Subject: Revision to Application to Reinstate the Provision for Loose Fuel Rods to be Shipped in the RA-3 Packaging

Explanation of Changes by Page

## CRITICALITY SAFETY EVALUATION RA-3 FUEL BUNDLE CONTENTS

Figure 5c Maximum allowed number of damaged packages, 2N, with product container contents

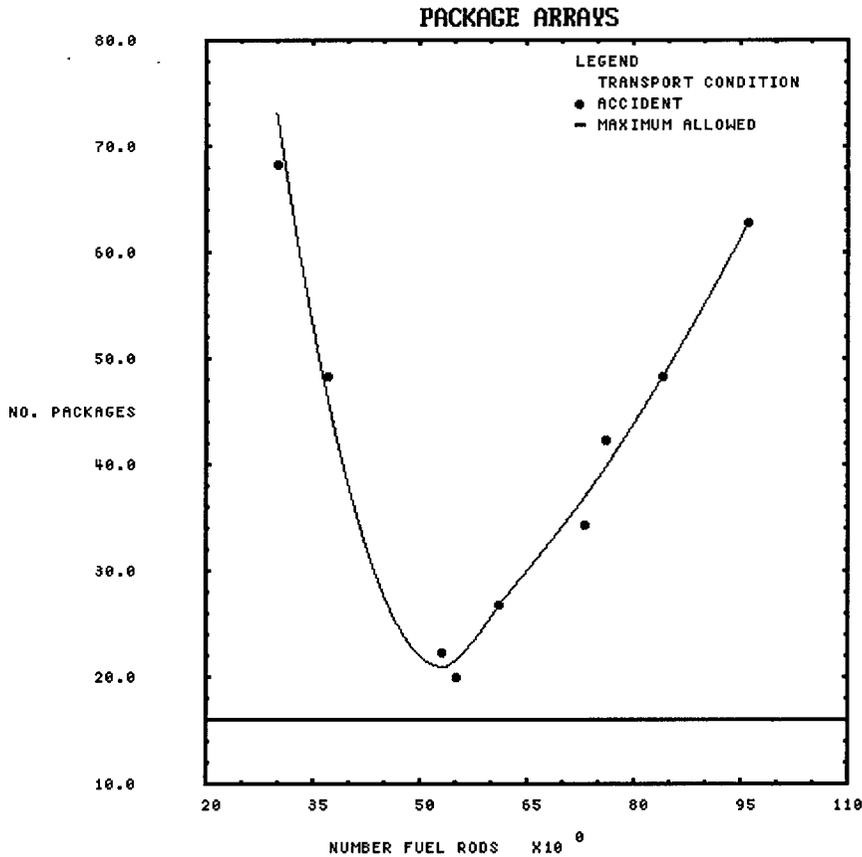
Page 1	Changed the N value to 8 and the TI to 6.3.
Pages 22, 23, 24 and 25	Starting with case ra10 - s6, we renumbered the cases and provided additional information to describe optimal fuel rod pitch.
Page 26	Replotted Figure 5c and limited the maximum allowed to $2N = 16$ .
Page 27	Corrected reference from Criticality Index to Transportation Index and reflected the revised number of maximum packages per shipment.

Each value for 2N is plotted versus the number of fuel rods that corresponds to the value determined for a specific array size as shown in Figure 5b. This demonstrates that there is a maximum number of packages allowed for which the damaged array is subcritical independent of the number of fuel rods loaded in the product container. This maximum allowed value for 2N shall be no less than 16 as shown in Figure 5c.

Under hypothetical accident conditions, an infinite number of packages with a bundle of 20 fuel rods loaded directly in the channel assembly is subcritical. Therefore, 2N is equal to infinity when the product container is not used. A maximum of only 16 damaged packages remain subcritical when the product container is used, and 2N is equal to 16 when the product container is used.
